In Reply Refer To: HSSD/B-164

Thank you for your August 14, 2007, letter requesting the Federal Highway Administration's (FHWA) acceptance of an F-shape portable concrete barrier wall as a test level 3 (TL-3) device for use on the National Highway System (NHS). Accompanying your letter were drawings of the details of the barrier, connections, and reinforcement and a comparison of this design with previously crash tested barriers. You requested that we find this device acceptable for use on the NHS under the provisions of National Cooperative Highway Research Program (NCHRP) Report 350 "Recommended Procedures for the Safety Performance Evaluation of Highway Features."

PRECAST TRAFFIC BARRIER SERVICE CONCRETE

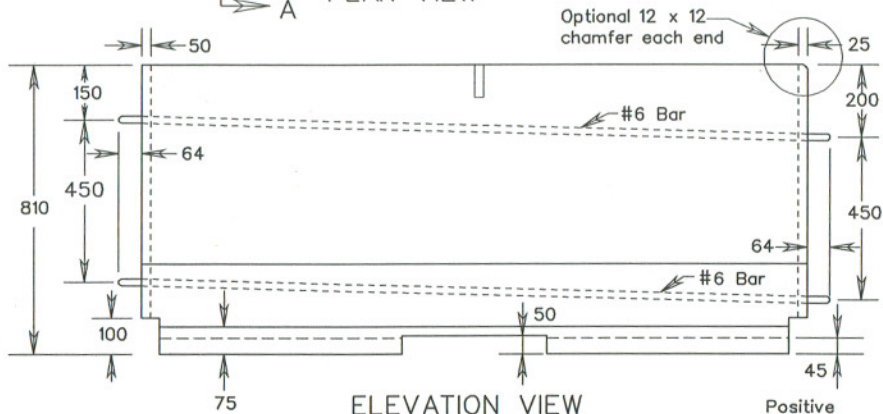
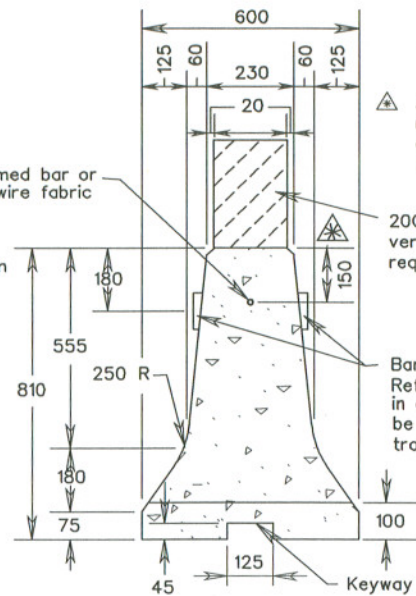
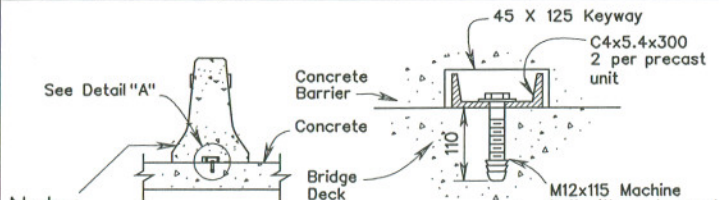
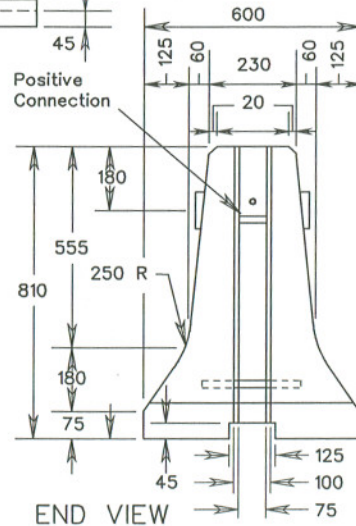
The barrier segments were fabricated in accordance with the Virginia Department of Transportation (VDOT) drawing 501.45 (revised August 1997, copy enclosed for reference). The one difference between the VDOT design and the barrier design you are requesting is the lack of the #4 reinforcing bar at the top of the wall. The FHWA acceptance letter B-54 dated May 18, 1999, describes the VDOT barrier:

The VDOT barrier was found acceptable in both 10-foot and 20-foot long sections. An analysis of the reinforcing steel shows that, even minus the #4 bar noted above, the longitudinal steel in the barrier you requested is comparable to that found in other crash tested barrier segments such as the JJ-Hooks Temporary Barrier described in the FHWA acceptance letter B-52 dated March 26, 1999.

The F-shape portable concrete barrier wall described above and detailed in the enclosed drawing is acceptable for use on the NHS as it is deemed an equivalent material meeting NCHRP 350 TL-3, when proposed by a highway agency. The connection pin, nut, and washers should be at least 1 inch in diameter and secured with nuts and washers as were the crash tested VDOT barrier segments. Barrier segment lengths may be 10 feet or 20 feet.
